September 6, 2022

Subject: Sudbury-Hudson Transmission Reliability and Massachusetts Central Rail Trail Project (DEP File # 301-1287) OOC Issued 02/04/2021 Notification of Minor Change and Request for Administrative Approval

Attached please find three plan sheets showing the proposed minor change that upon administrative approval would replace the corresponding sheets in the plan set previously approved by the Commission.

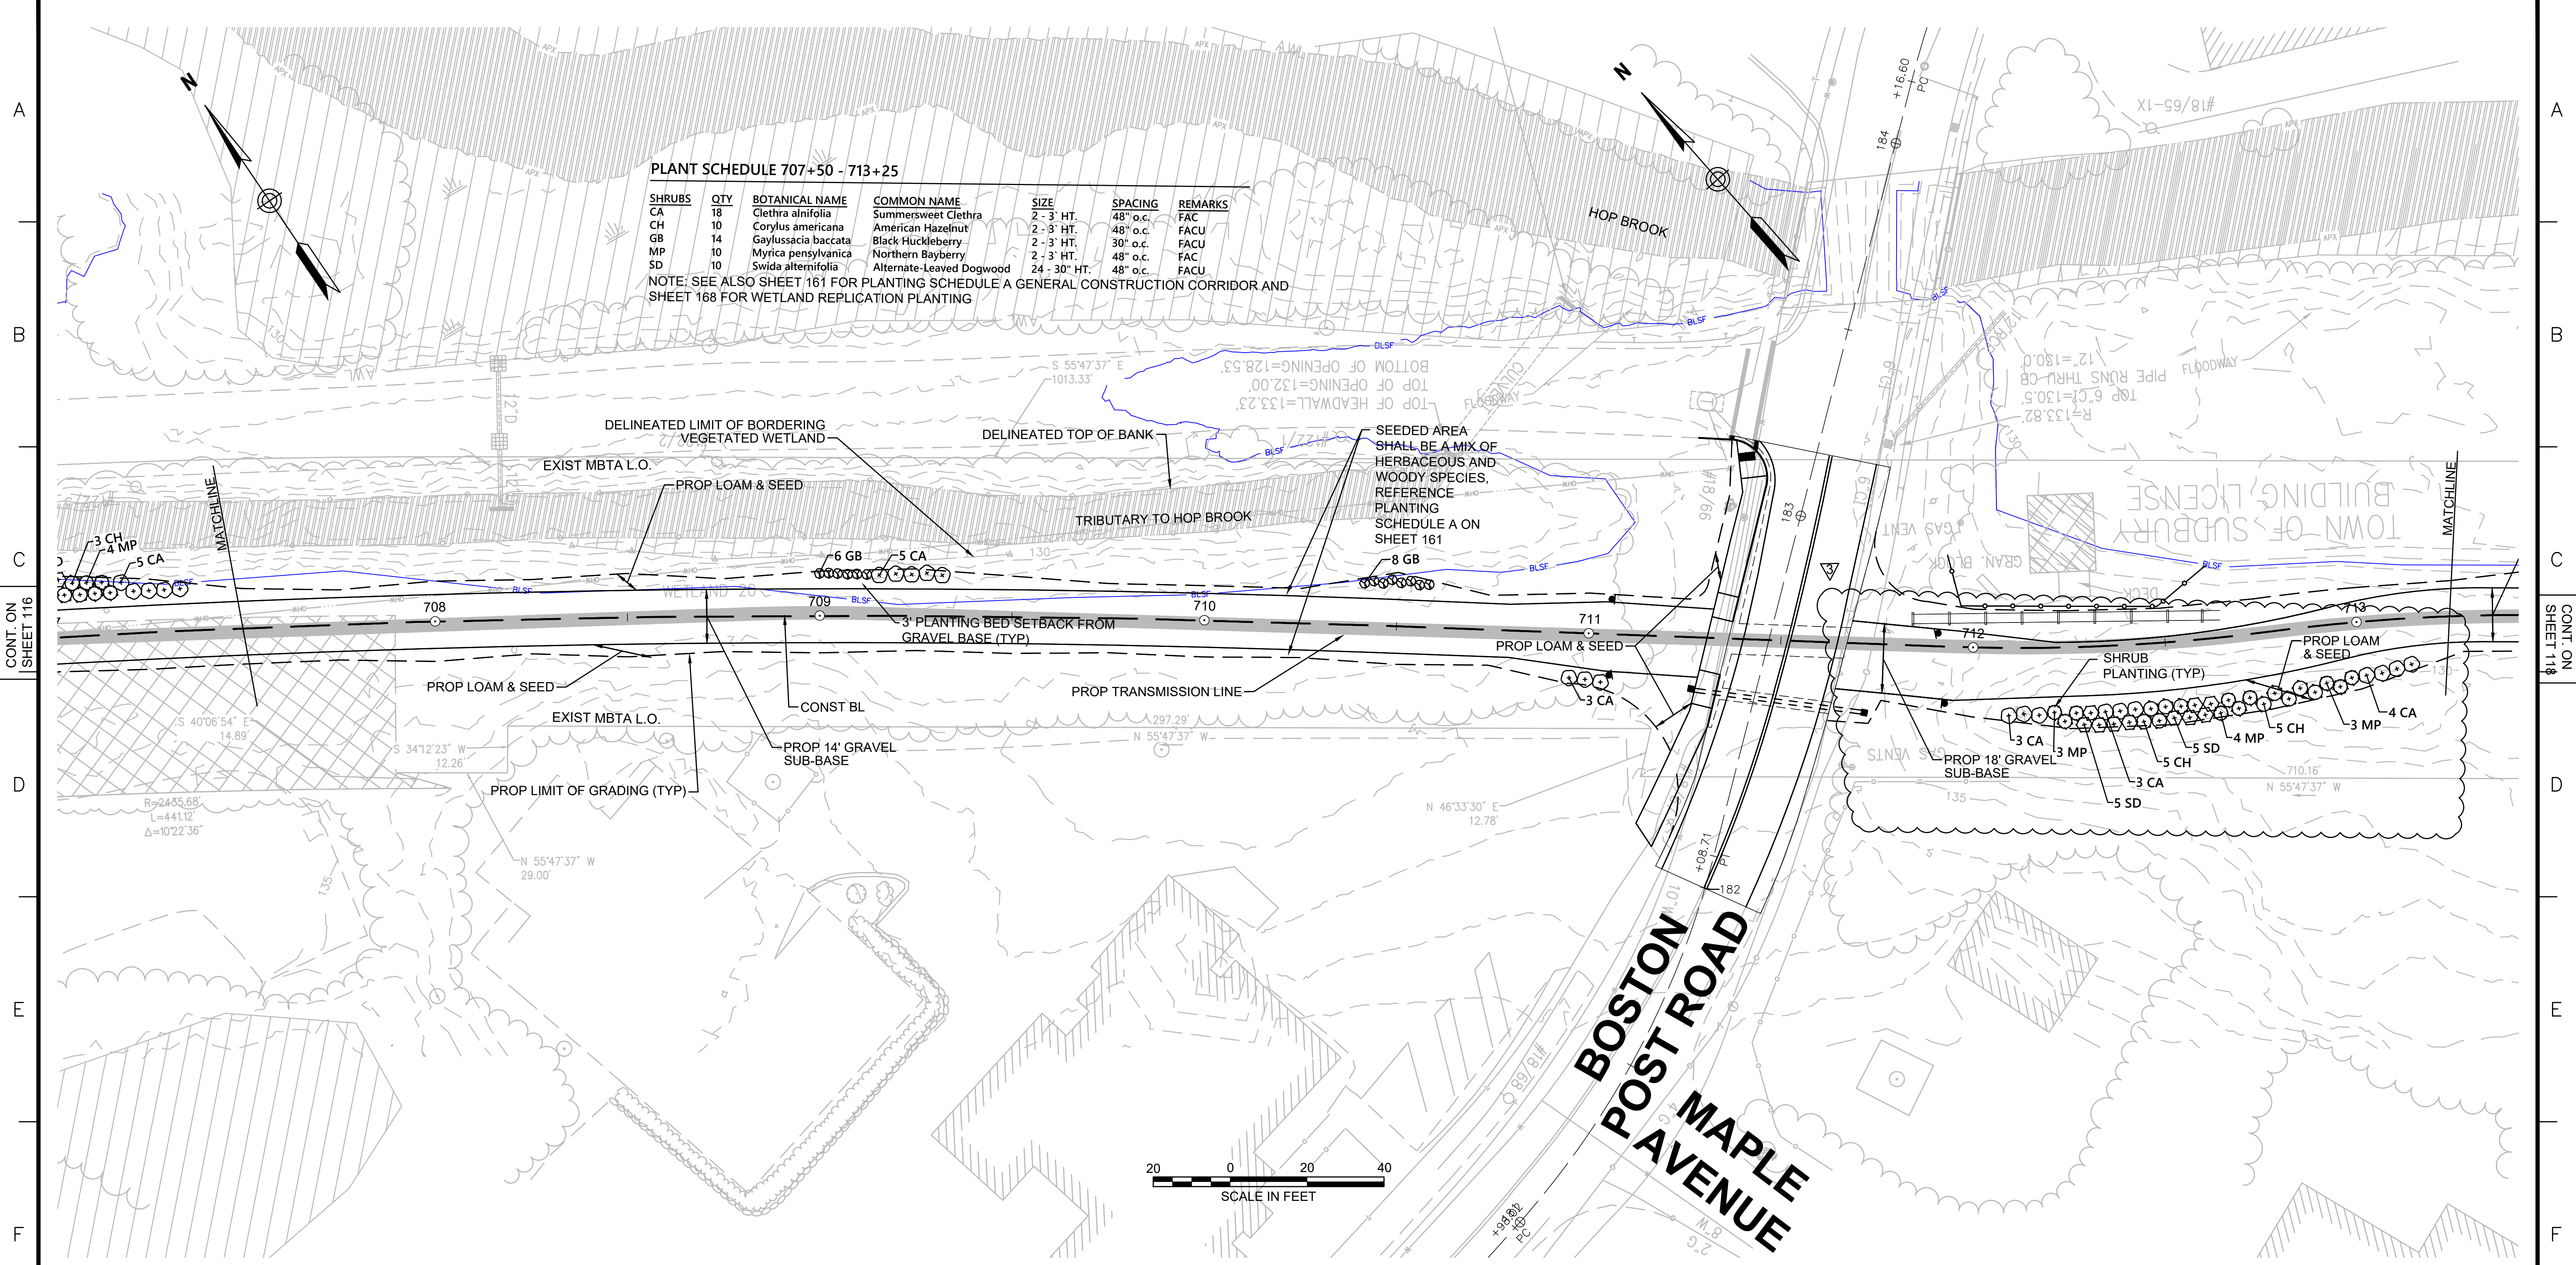
updated plans will be restored with the same native woody shrub plantings and native herbaceous seed mix that was approved for the other restoration in this area.

PLAN 326 OF 349

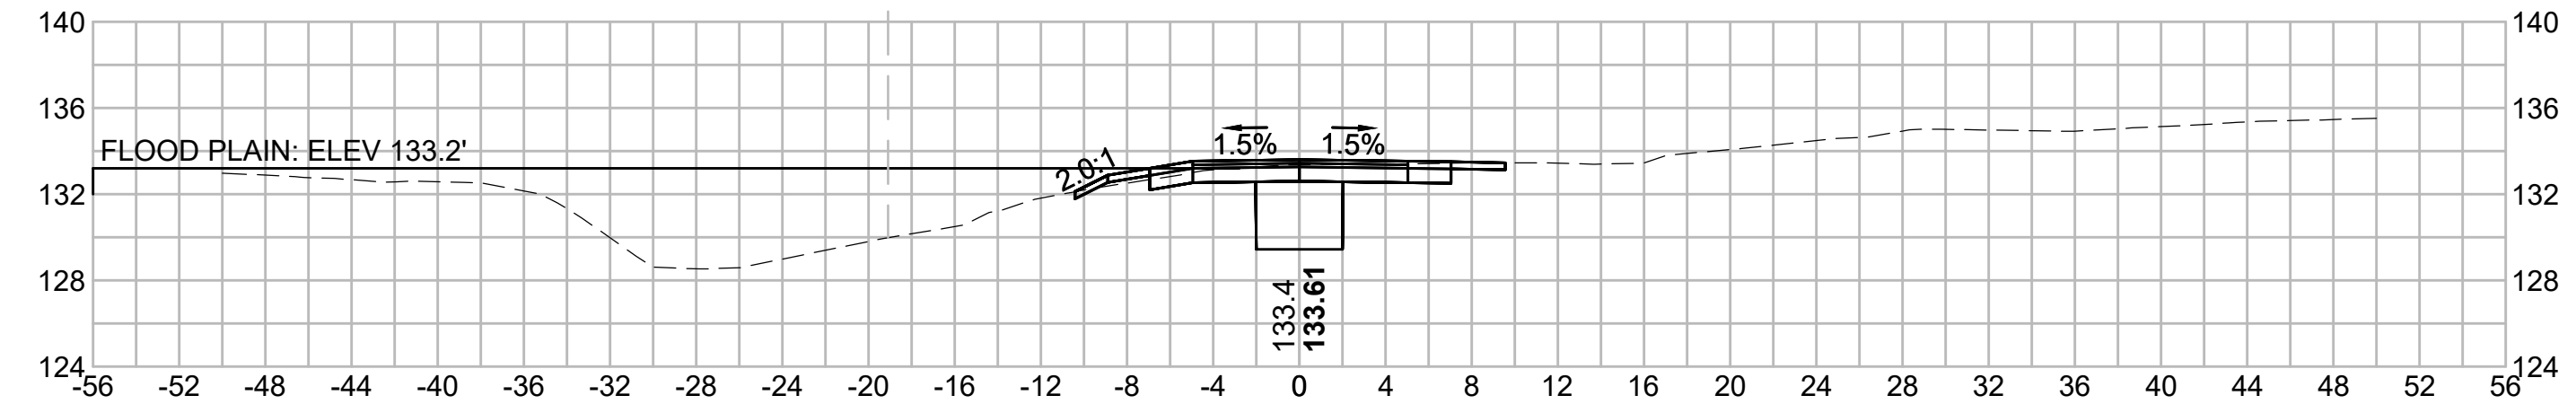
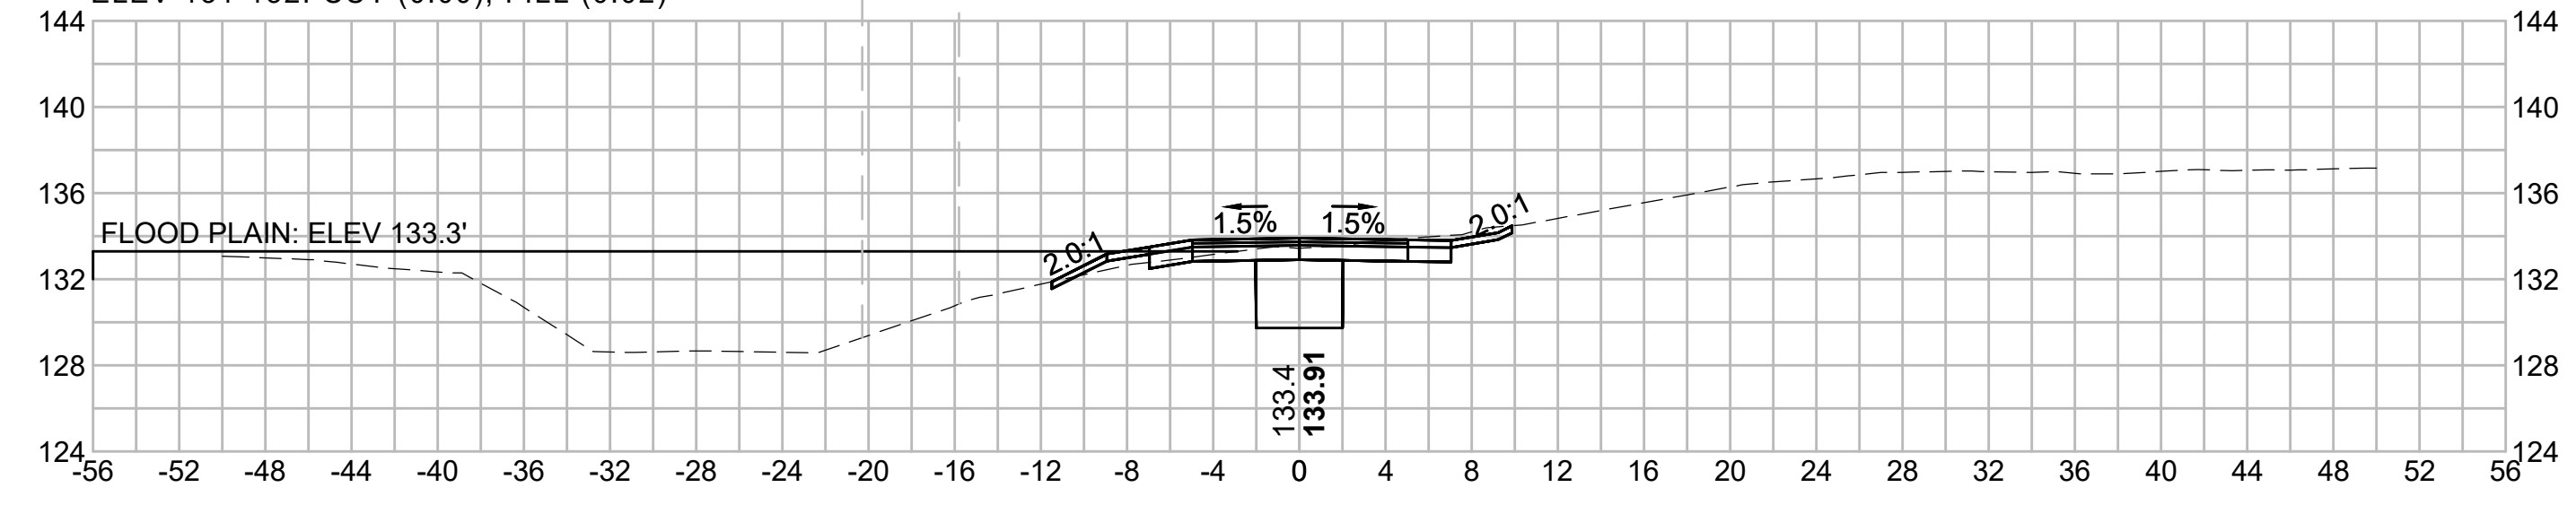
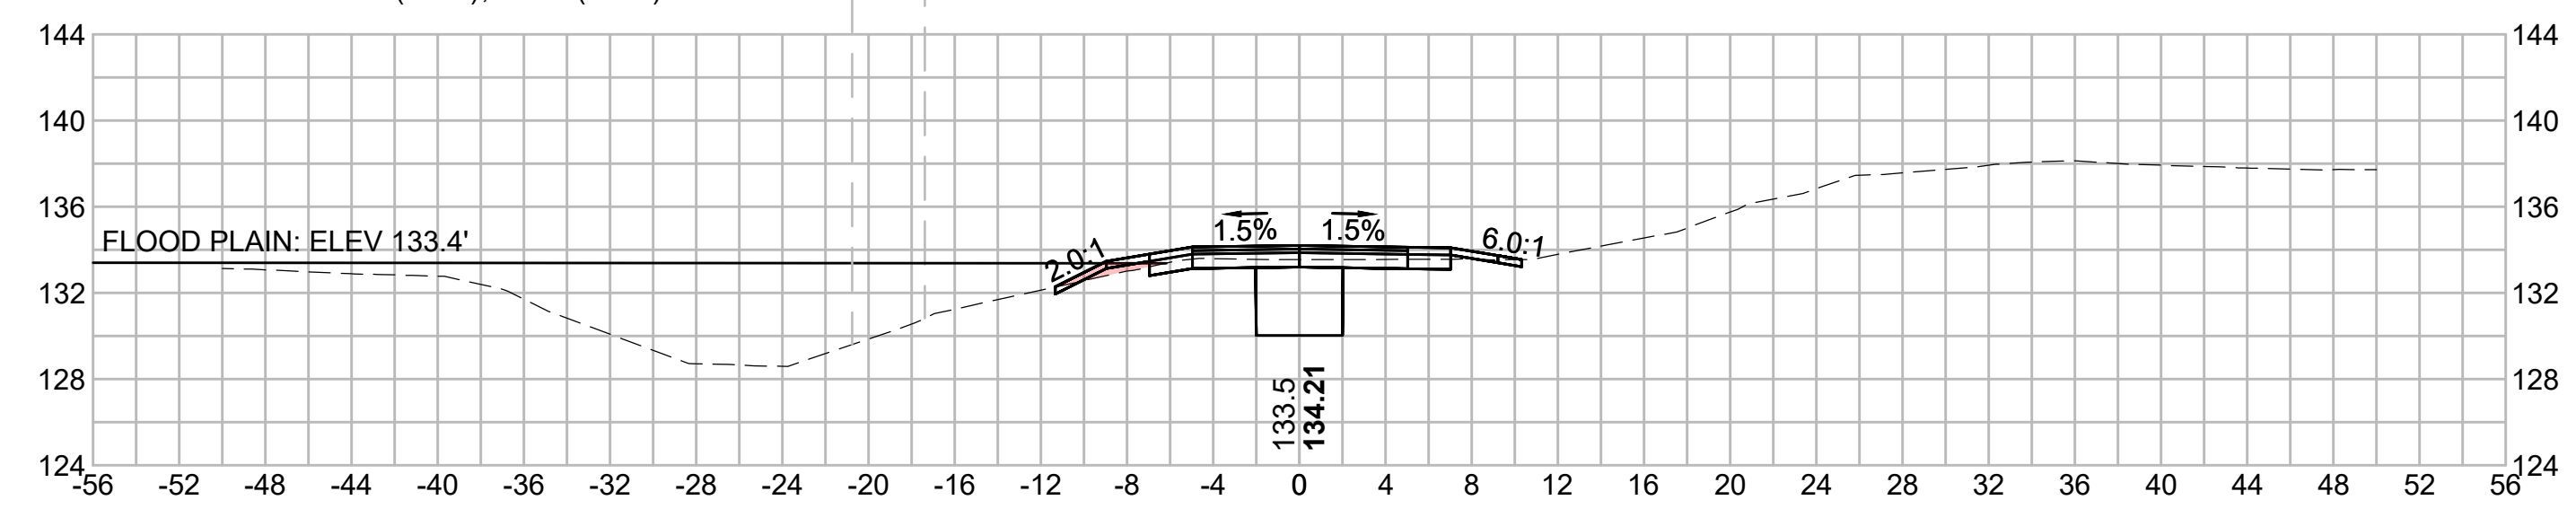
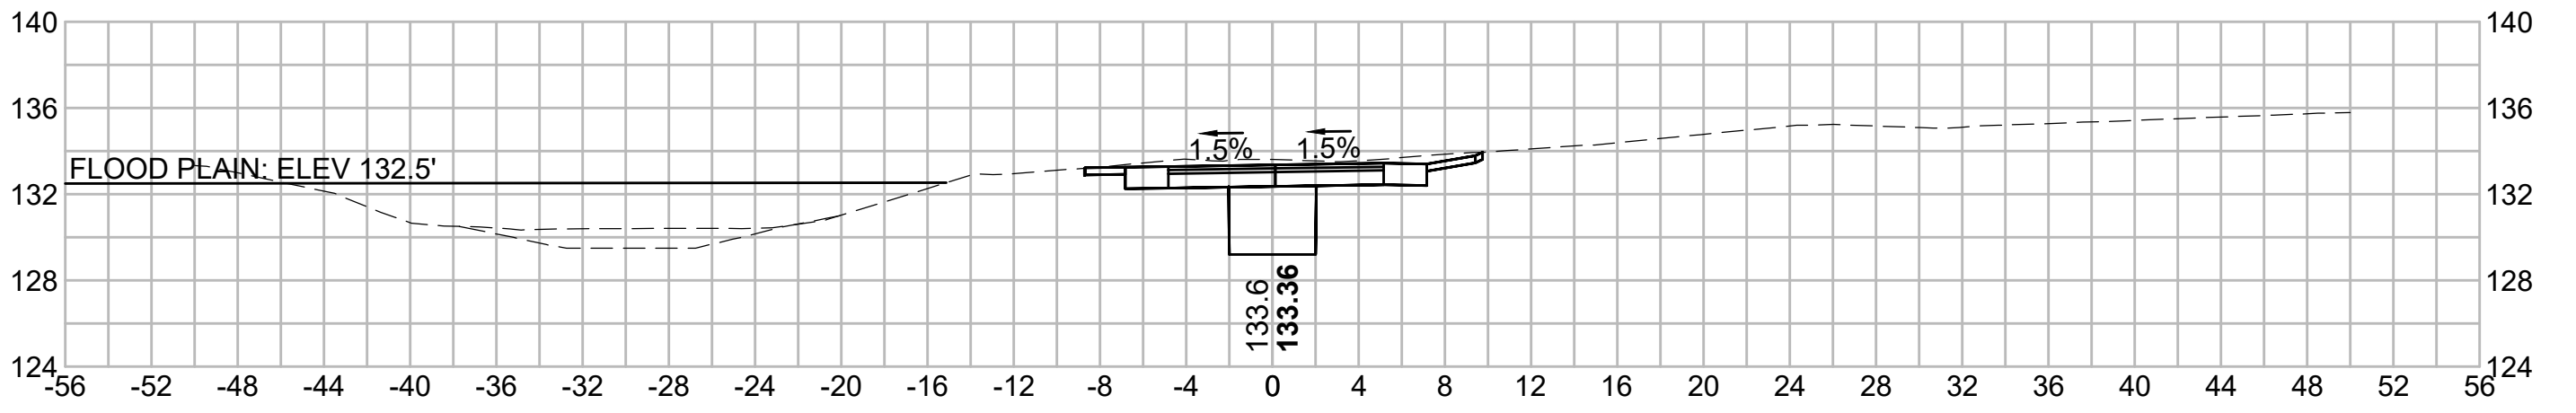
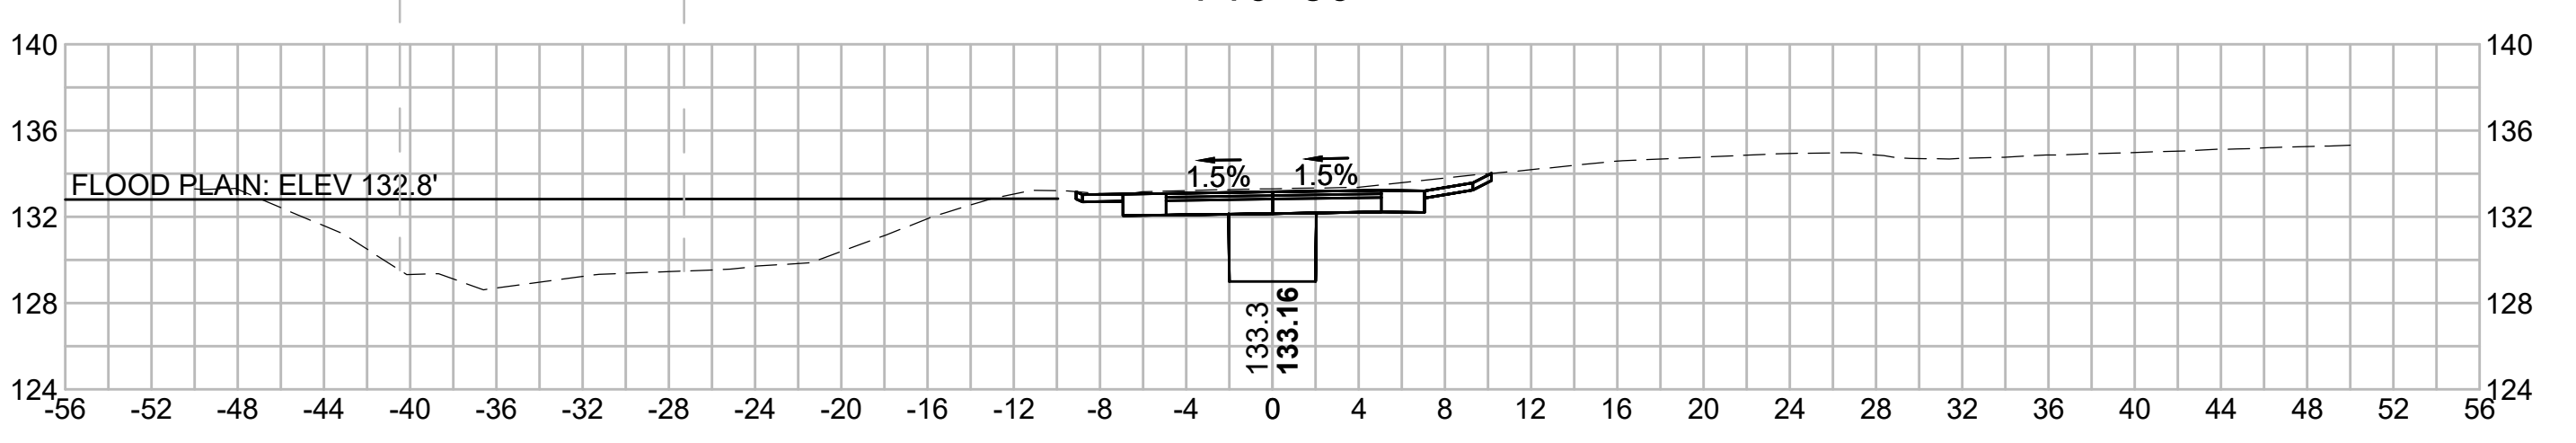
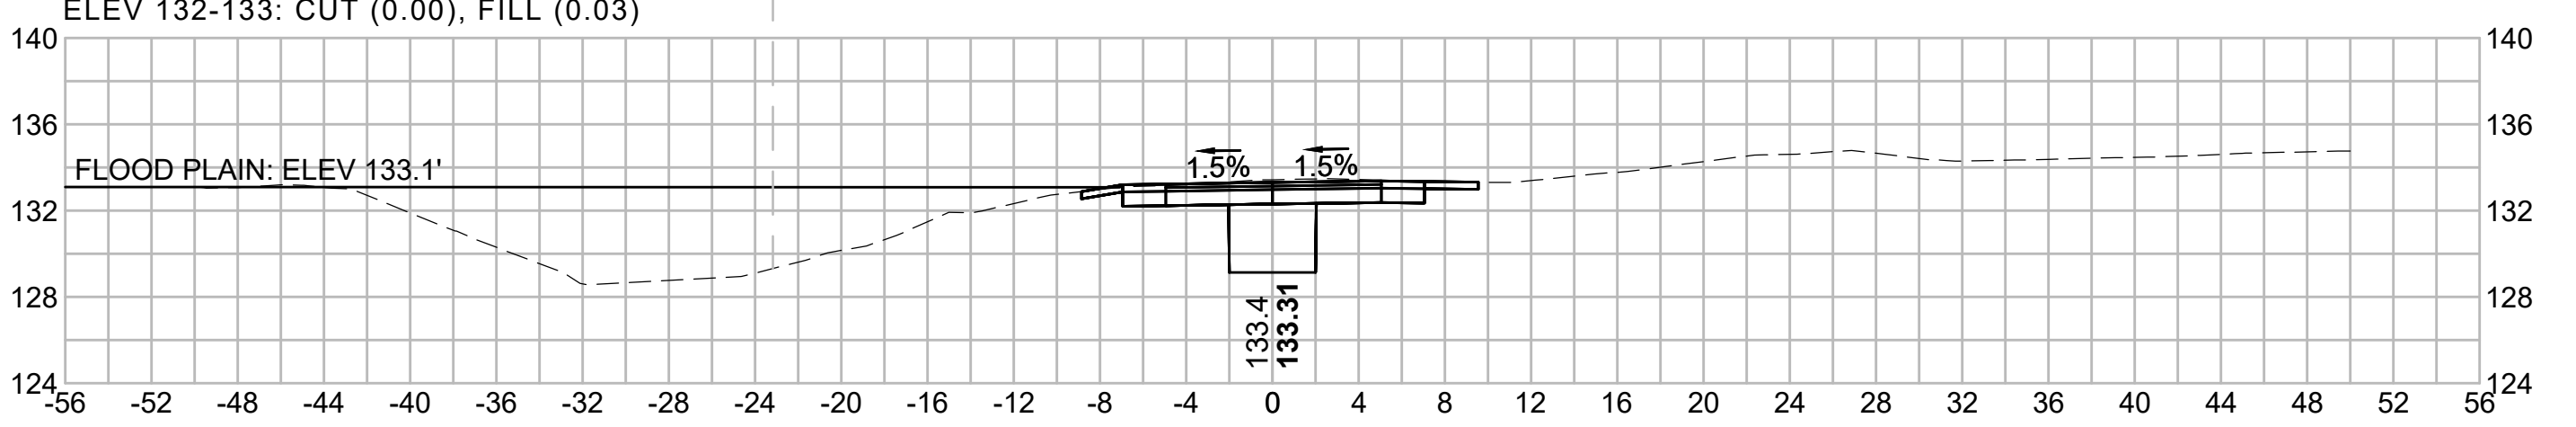
3	PATH REALIGNMENT 710+50 TO 713+50	08/19/2022	
N O.	DESCRIPTION	BY	DATE
	REVISION		APPR.
